RE: Revised Aquifer Recovery Test Activities at the Eastern Plume, Naval Air Station Brunswick, Maine

This plan was revised on the basis of regulator comments received on the draft aquifer recovery test letter issued on 31 October 2007. The responses to comments received from the EPA (dated 14 November 2007) and the MEDEP (dated 16 November 2007) are provided in Attachment A.

**RESPONSE TO COMMENTS FROM THE
STATE OF MAINE DEPARTMENT OF ENVIRONMENTAL PROTECTION –
BUREAU OF REMEDIATION AND WASTE MANAGEMENT
ON THE DRAFT AQUIFER RECOVERY TEST ACTIVITIES AT THE EASTERN
PLUME, DATED 31 OCTOBER 2007,
NAVAL AIR STATION BRUNSWICK, MAINE**

**RESPONSE TO COMMENTS FROM THE
UNITED STATES ENVIRONMENTAL PROTECTION AGENCY
NEW ENGLAND – REGION 1
ON THE DRAFT AQUIFER RECOVERY TEST ACTIVITIES AT THE EASTERN
PLUME, DATED 31 OCTOBER 2007,
NAVAL AIR STATION BRUNSWICK, MAINE**

The table below provides the proposed observation points for each extraction well. The locations of the proposed 23 observations points are located on Figure 1.

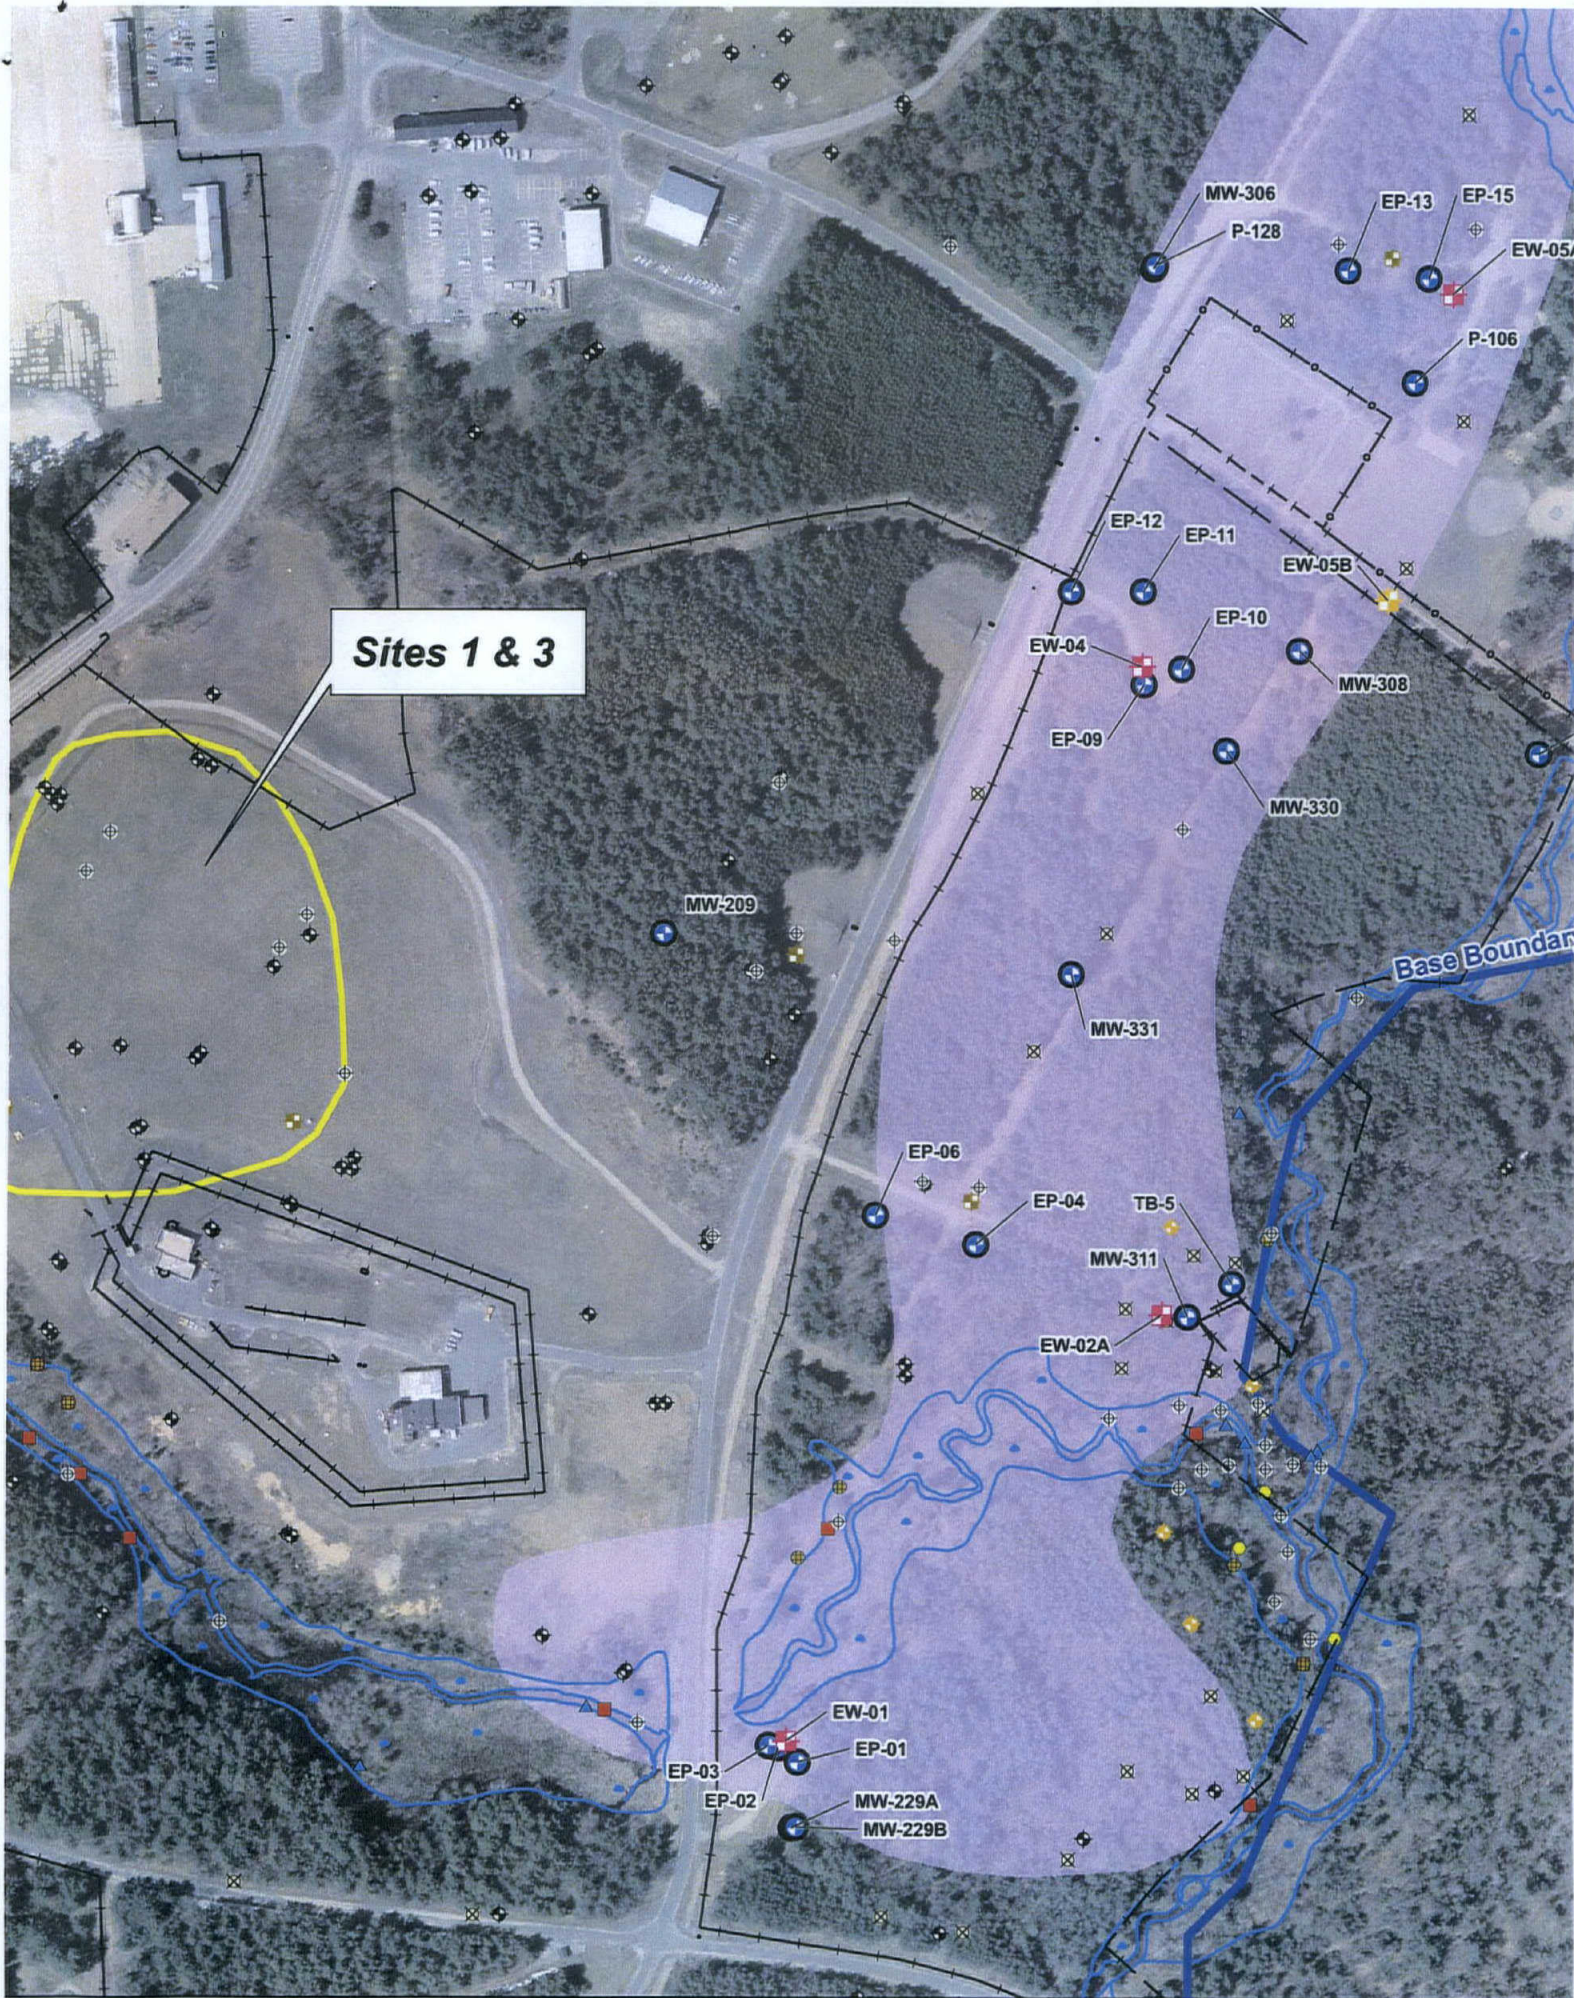
1. MEDEP supports the comments submitted by USEPA, particularly the need to include a figure and the relative screen elevations and lengths in the table along with the geologic information. Overall the proposed test methods and expected duration are acceptable and reasonable.

1. Editorial comment: In the future, please include a figure highlighting all the wells to be relied on for the test. Also include a table with extraction well & monitoring well screen depth information.

Response: The requested figure and screen elevations have been added to the Revised Letter.

Response: The requested figure has been added to the Revised Letter.
